Memorandum

Subject: Weaknesses in the Entergy Study of the Reliability Impacts of Closing Indian Point Units 2 and 3.

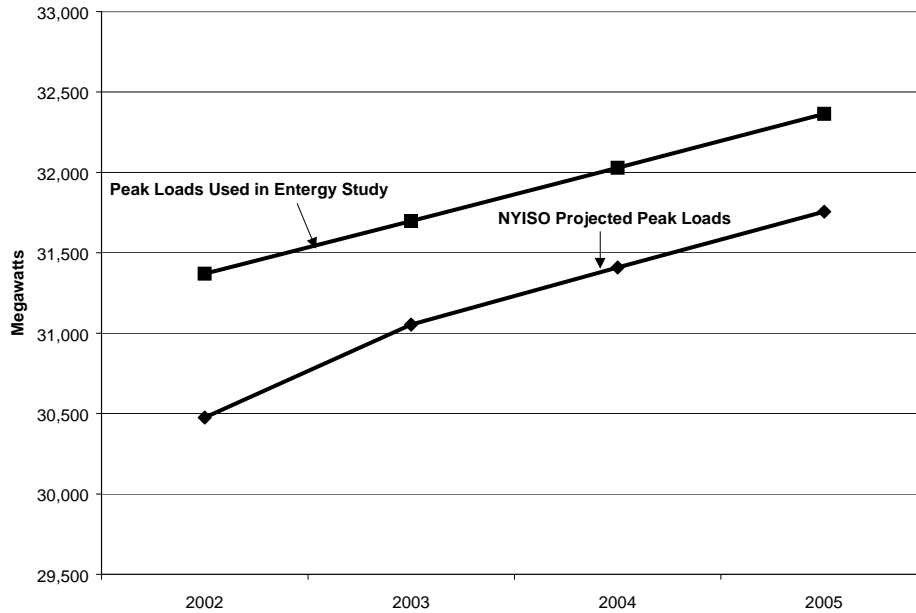
The following figure compares the peak loads assumed for the years 2002 through 2005 in the Entergy study with the peak loads for the same years projected by the New York Independent System Operator (“NYISO”) in its recent March 2002 report, “Power Alert II, New York’s Persisting Energy Crisis.” As you can see, the peak loads assumed in the Entergy study are significantly higher than the peak loads projected by the NYISO.

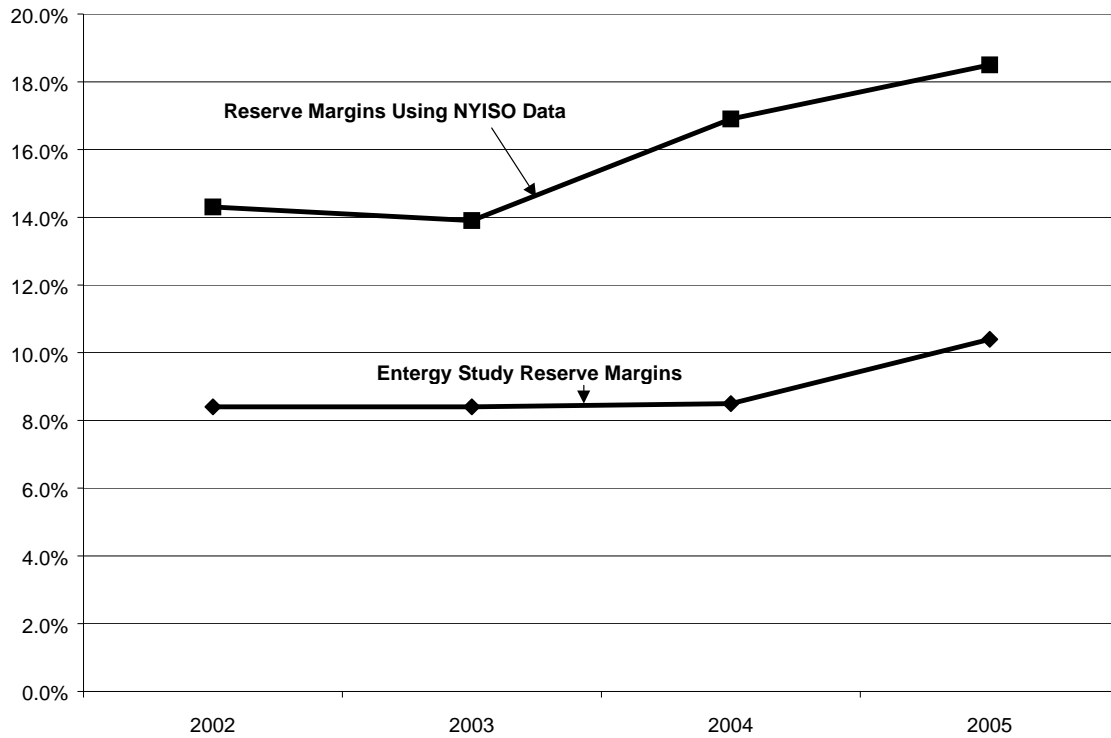
The following figure compares the system reserve margins that Entergy claims would exist in New York State if Indian Point were closed with the reserve margins calculated in the table above. As can be seen, using NYISO projected peak demands and NYISO and Siting Board information on future installed capacity leads to significantly higher projected reserve margins for each of the years 2002 through 2005.
